## Philbey, Janine (DPTI)

Please accept our written submission made in response to the Development Report released by Holmes Partners / Helen Dyer and Associates for the applicant Wunda Projects for the proposal at 6-10 Adelphi Terrace.

### **Major Development – Response to Development Report Adelphi Terrace, Glenelg – Integrated Hotel Development**

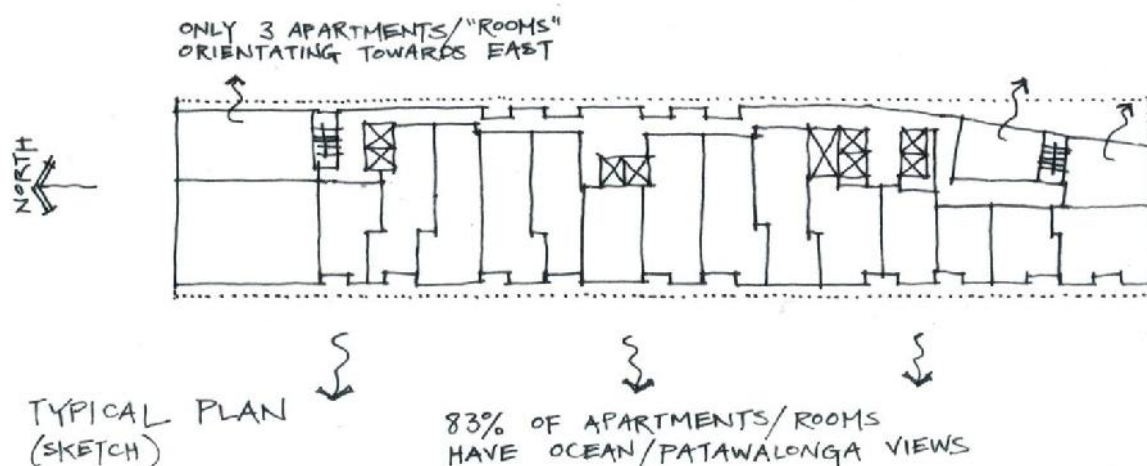
Quite clearly the height of this proposal is seriously at odds with the heights set out in the current Development Plan. Even considering future State Planning Strategy Initiatives (Development Plan Amendments / Metropolitan Growth Projects) which involve investigating the impacts of raising the height limits of buildings in this area at some point in the future to 8 or 10 storeys, a height of 12 storeys is excessive.

For every floor that is proposed the resultant impacts are compounded (the noise, traffic, overlooking, overshadowing and overbearing nature of the proposal).

***We would urge the Department to consider limiting the height to a more reasonable (albeit still non complying) height of 6 storeys.***

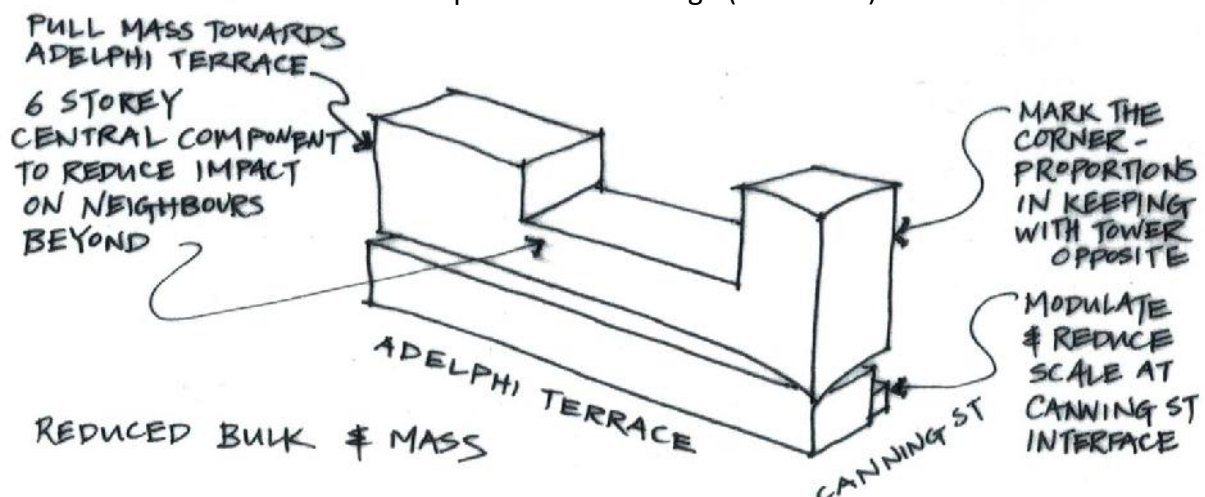
The design intent of stretching, squashing and shifting the striated forms results in a precarious and top heavy building with a “Jenga”-like appearance which increases the feeling of an overbearing form.

The architectural design report includes reference to large eaves which help sun control, large glazed areas to maximise views and a facade design which fosters strong visual connections. These may well be of benefit to the occupants of the building but there is little mention of how the design enhances the environment of its immediate neighbours.

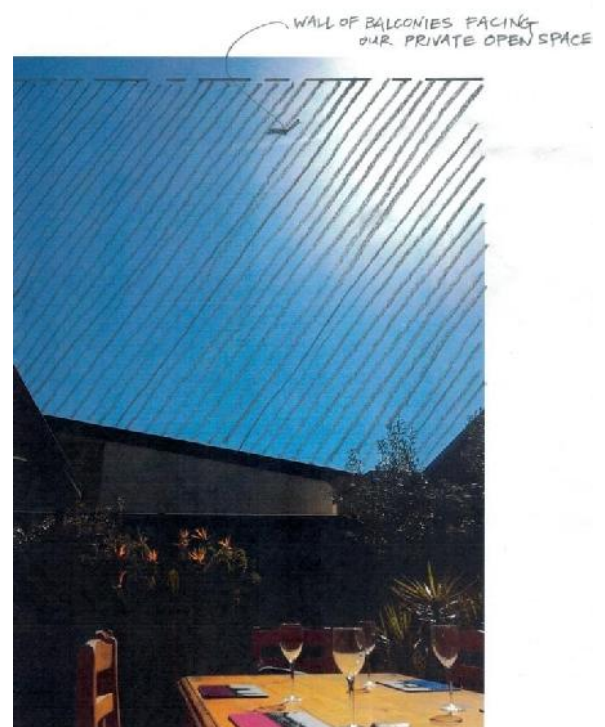
This is worsened by the fact that some of the upper levels cantilever out to offer almost no setback to Canning Street at all. Such an overbearing, unsympathetic approach to street setbacks is neither envisaged nor consistent with the design intents of these zones and creates a jarring and unsympathetic imposition on the existing context.

***We would urge the Department to recommend the proponent submit detailed information relating to the streetscape and specifically how the transition is made between the podium and the adjacent residences. In addition it is our recommendation that increased setbacks to Canning Street be requested for upper levels as well as articulation and modulation of the form fronting Canning Street to better address the existing context.***

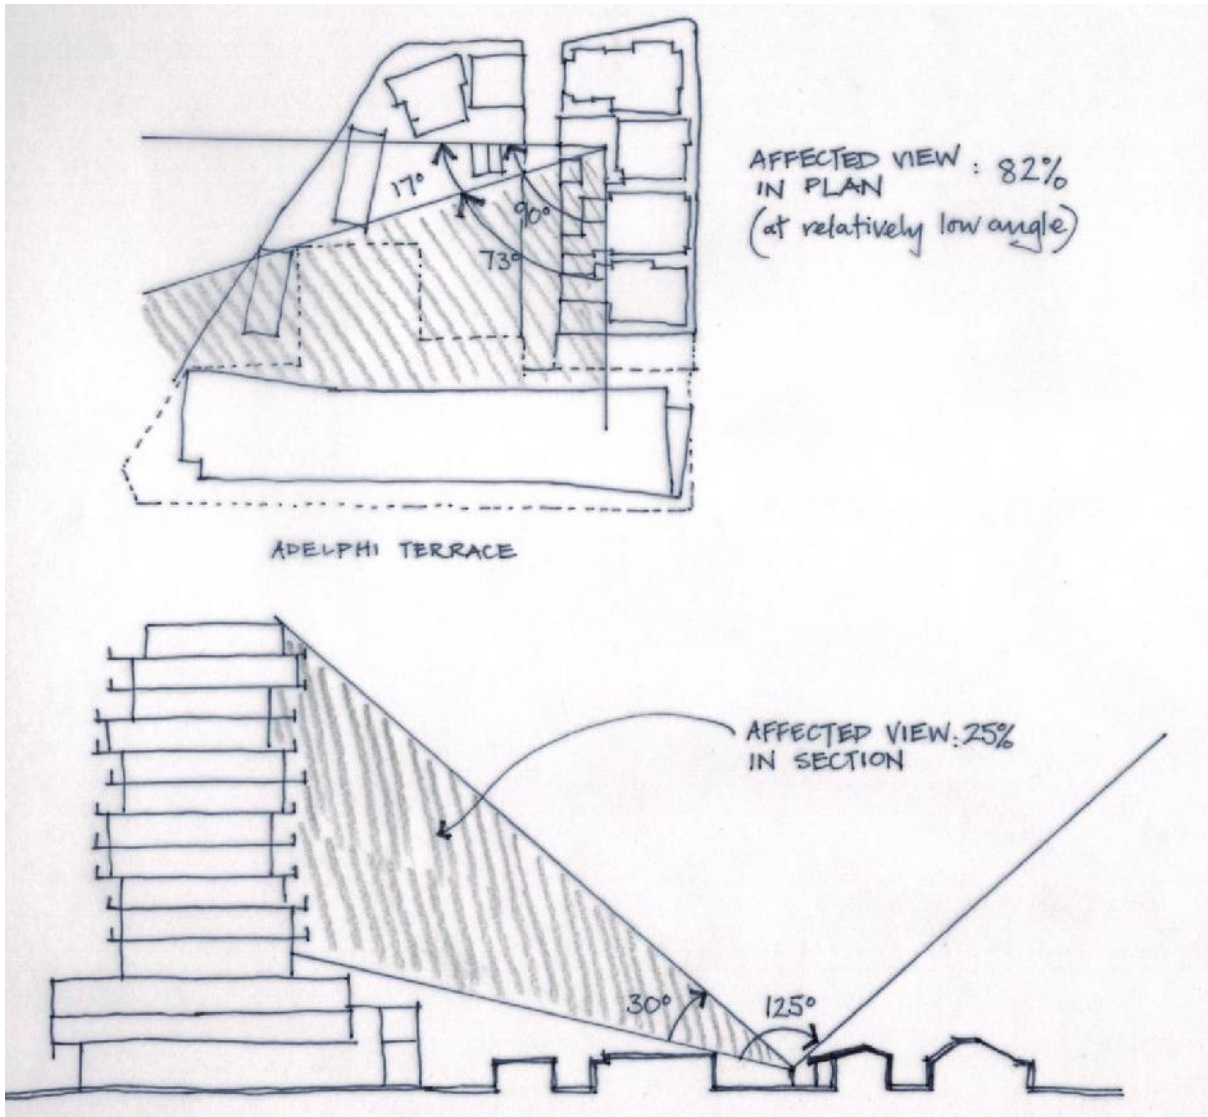
Incidentally the applicant may wish to amend the drawings and remove the images showing occupants of the tower block on their balconies peering through binoculars as this does little to appease residents' fears in relation to overlooking.

***We urge the Department either:***

- ***request the applicant orientate rooms to face Adelphi Terrace - a technique employed in a number of local high rise buildings, or:***
- ***include a condition or require a change be made requesting the applicant provide angled screens/profiled balustrade edge to the outer face of the balconies to prevent downward views to the satisfaction of the Department:***
- ***include a condition ensuring an opaque balustrade be provided to a height of 1100mm (or at the very least 700mm) ABOVE FINISHED FLOOR LEVEL.***

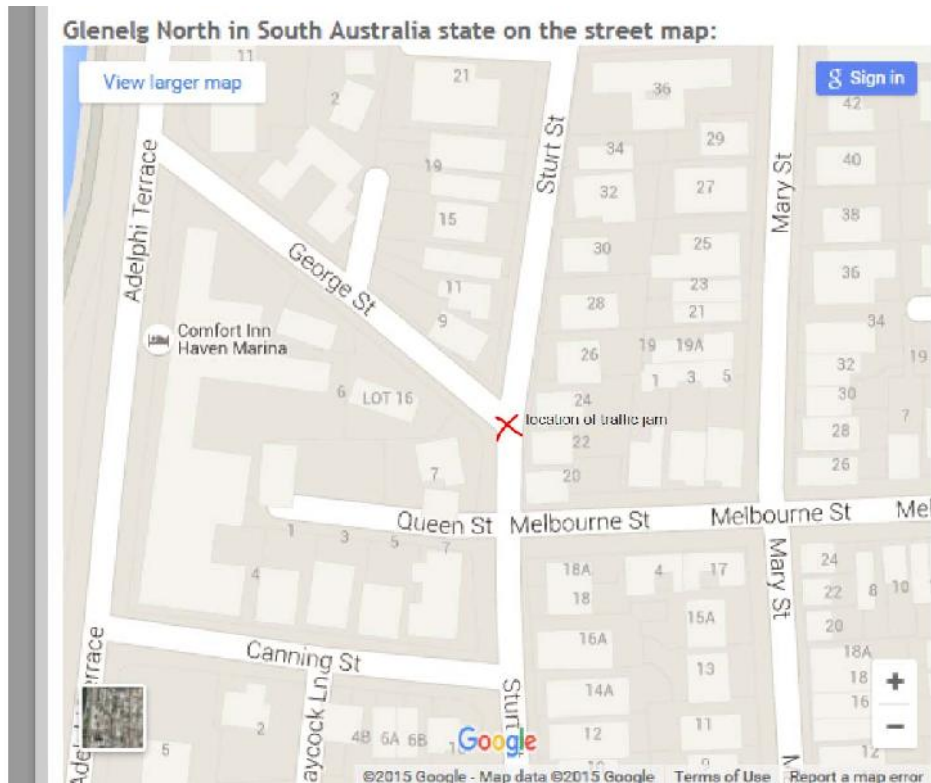
*There are four plus pages of theoretical traffic rates that conclude with the following sentence “Given that the forecast additional trips relating to the subject development*

*will be relatively low, the access of the on-site car park with George Street will operate satisfactorily.” With a building at least three to four times the capacity of the current hotel how do they arrive at a relatively low increase in trips? Traffic that was previously handled by six crossovers will now all be funneled down a narrow side street to be handled by one crossover with a significant increase in the number of users. This is likely to result in queuing and traffic jams as people cannot exit in their chosen direction due to parking on both sides of George Street making it virtually only one lane wide.*

*Parking restrictions cannot be introduced here as many local residents do not have off street parking available and need to park on the street. We have only lived here for just over a year but have quickly learnt that if we are going to have visitors that we need to park our car on the street in order to ensure a parking spot in our driveway for our guest. Not all of our neighbours are lucky enough to have off street parking and could be faced with the option of not having somewhere to park when they arrive home from grocery shopping on a Saturday morning as fulltime working people often do. MFY have obviously not witnessed the existing traffic situation in this area when all of the surrounding streets are consistently fully parked out on weekends creating a situation where owners find it difficult to park outside their own house. There has literally already been traffic jams at the intersection of George, Sturt and Melbourne Streets in the last couple of months when we have experienced nice weather (see following picture of typical weekend parking).*

# VIEW LINE PHOTO A

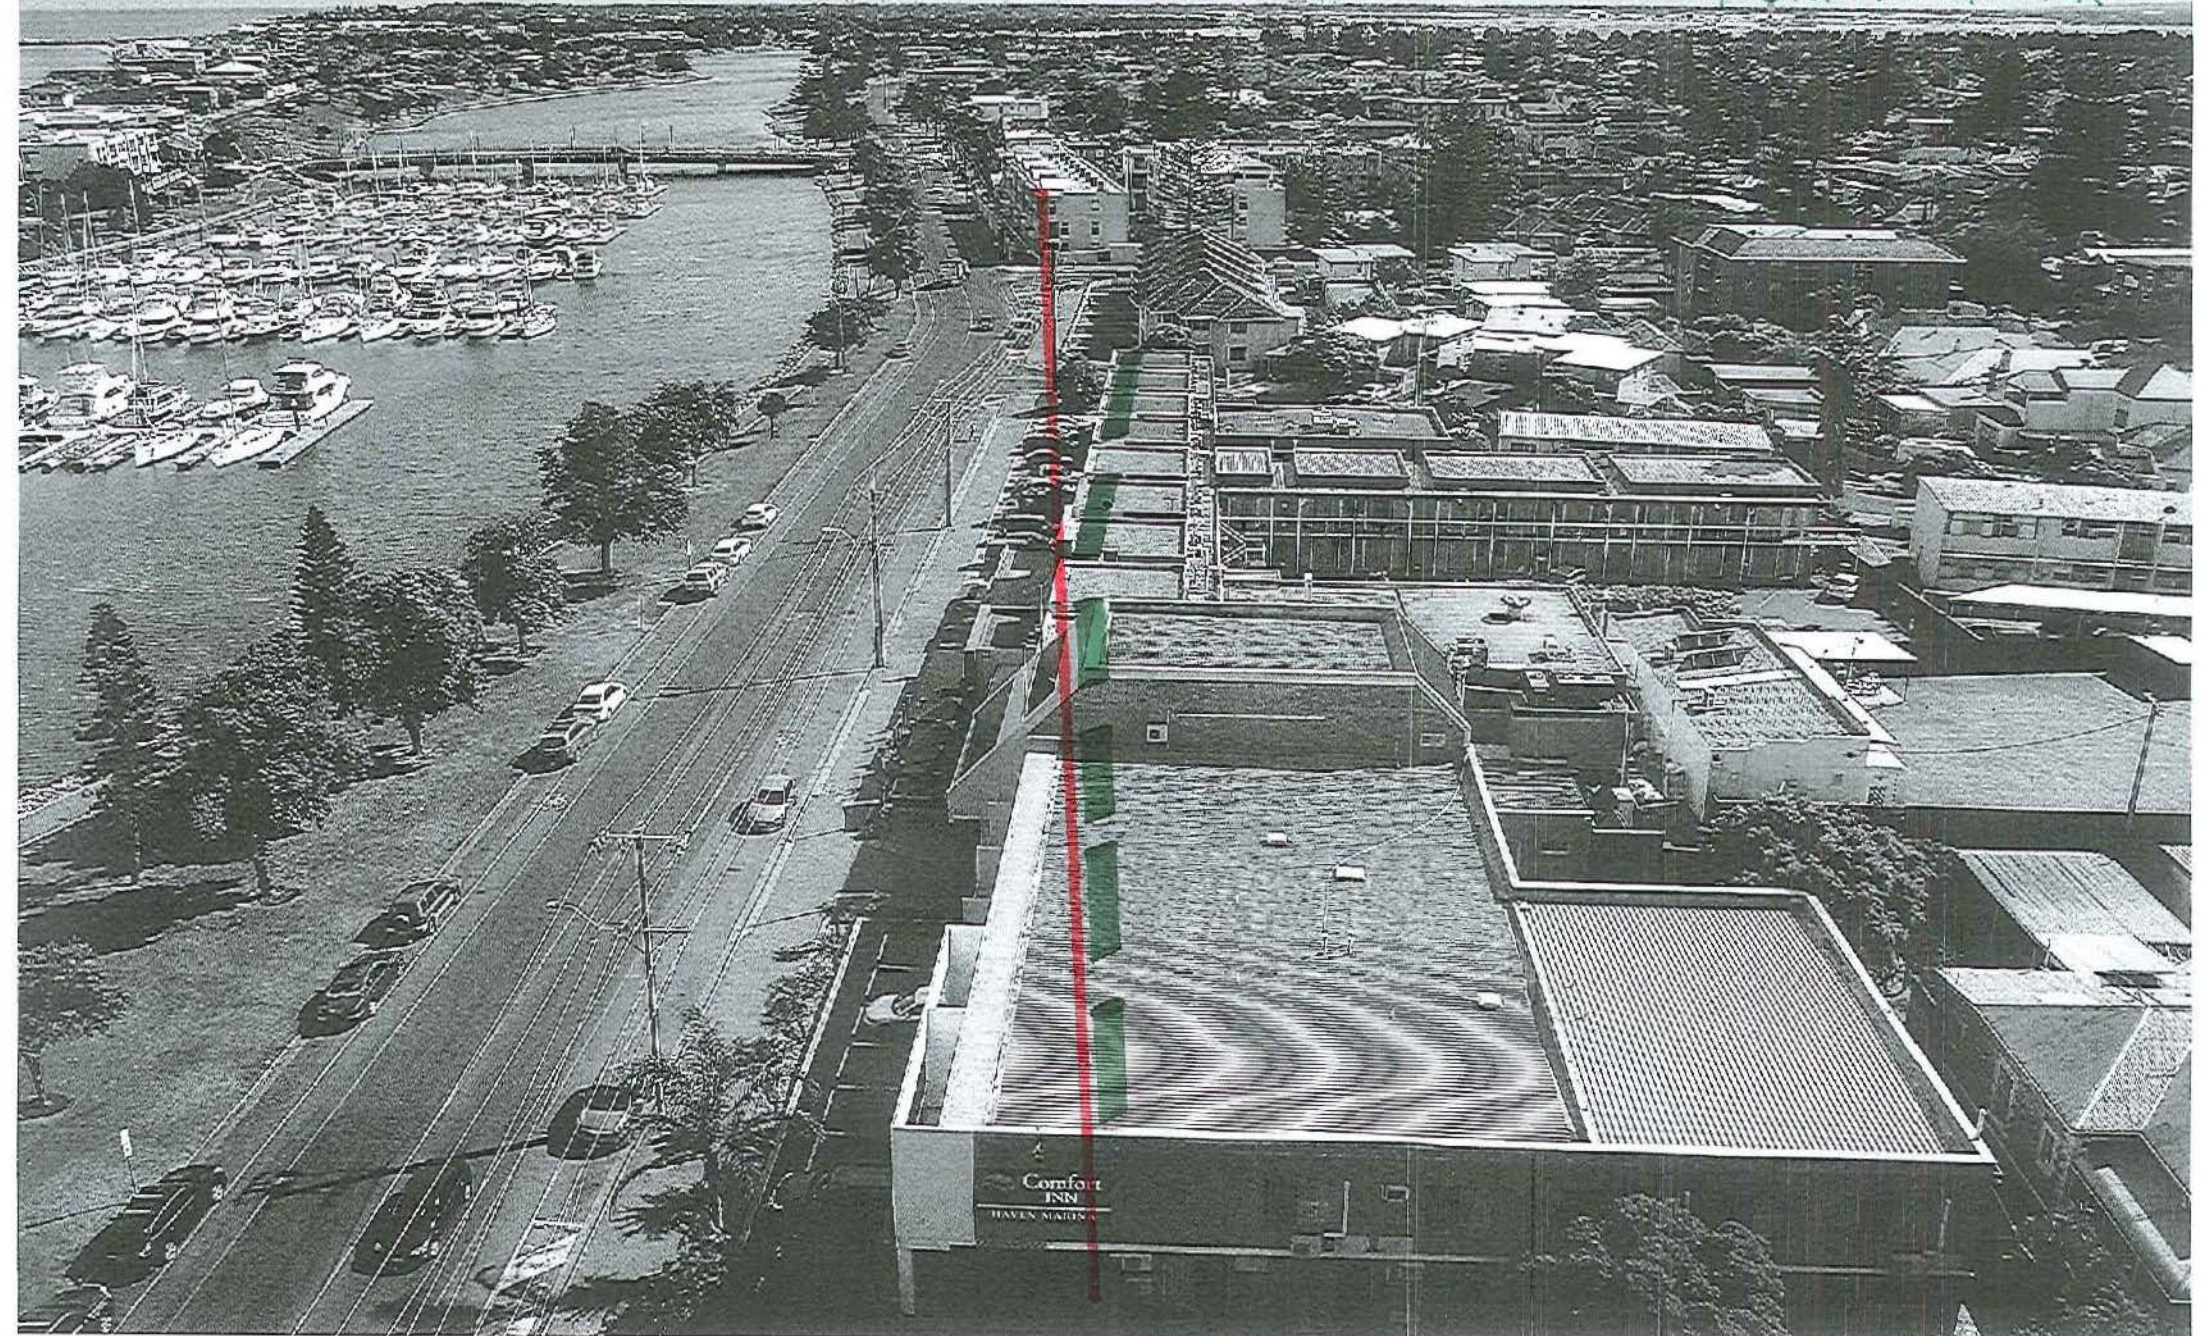
DESIRED MINIMUM PODIUM SETBACK

# VIEW LINE PHOTO B

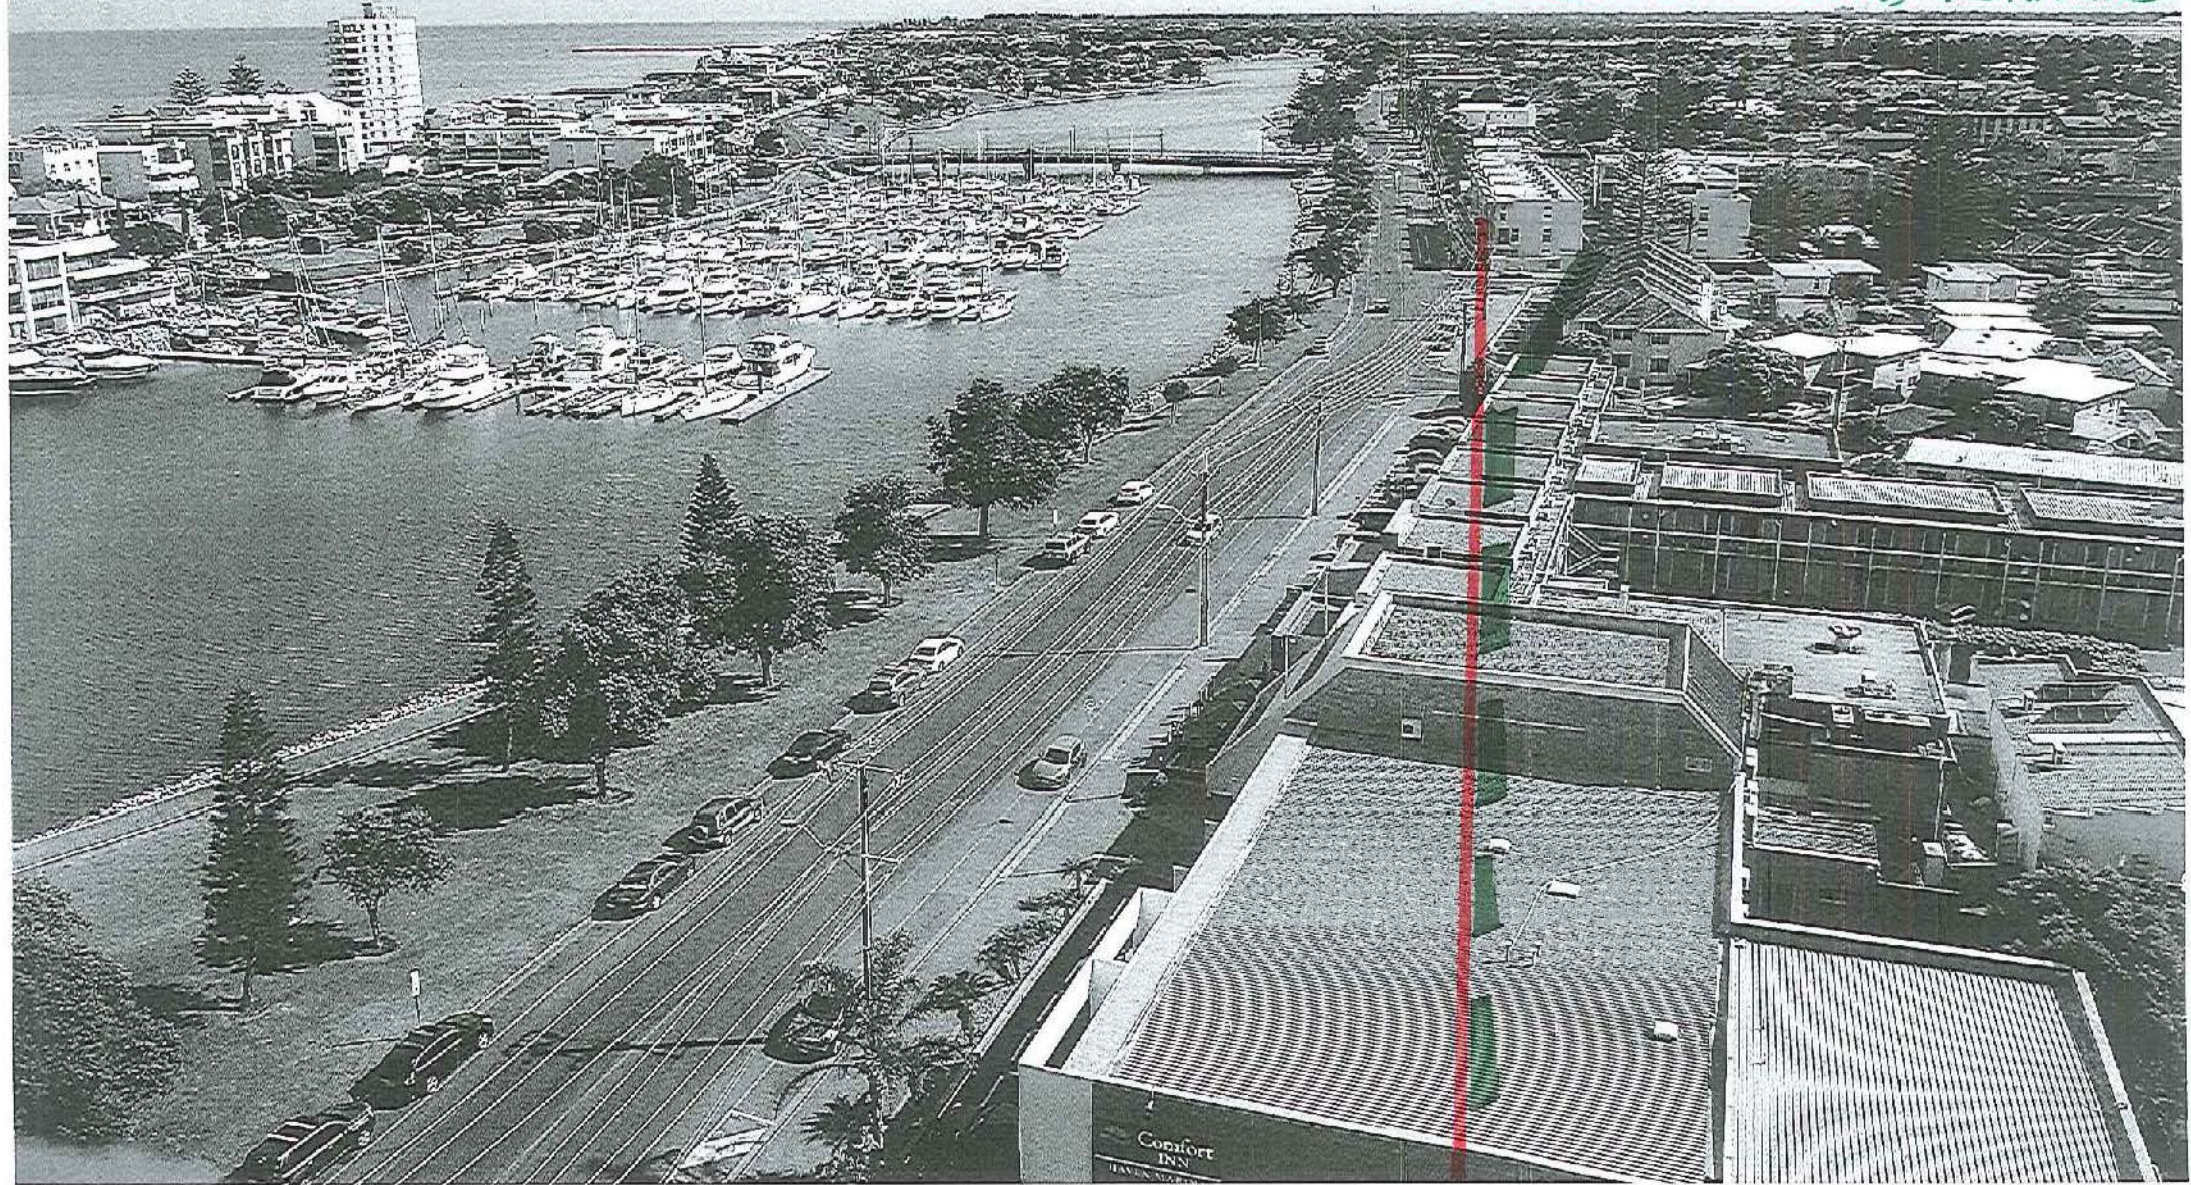
NO TOWER ELEMENT OR  
CANTILEVERED FLOORS FORWARD
